EMERGENCY AIRWORTHINESS DIRECTIVE

Number: **G-2021-0010-E**

ATA 28 – Fuel –Cylinder Quick Shut-off Valve Mounting Flange – Inspection / Replacement

Figure 1: *CB437 Flanged Adaptors for Quick Shut-Off (QSO) valves*

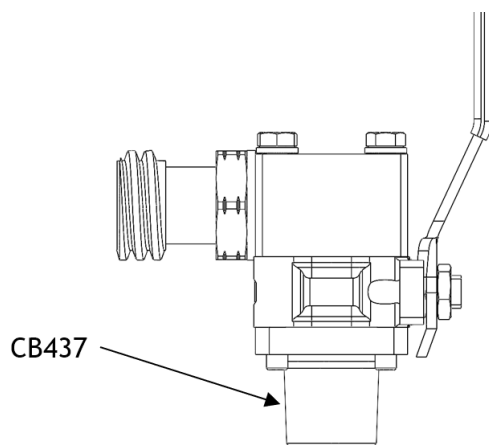
Certain Cameron Hot Air Balloon fuel cylinders are supplied with liquid offtakes that consist of a quarter turn ball valve mounted on a flanged adaptor (P/N CB437, see figure 1). Two recent batches of these adaptors have been manufactured with non-conforming (undersize) threads.

In certain cases, when the minimum sized adaptors are combined with cylinder bosses at maximum tolerance dimension and assembled to fuel cylinders, the thread can impinge (“bottom out”) on the cylinder boss. Although the required tightening torque value can be achieved at installation, the torque required to unscrew the flange could be below the minimum value. In extreme cases the adaptor may be unscrewed by hand.

For the reasons described above, this AD requires a one-time inspection of each affected fuel cylinder for leakage around the threaded joint between the QSO valve adaptor flange and the cylinder boss and, depending on findings, removal from service of the affected fuel cylinder. This AD also requires modification of each fuel cylinder by replacement of the affected part with a serviceable part.
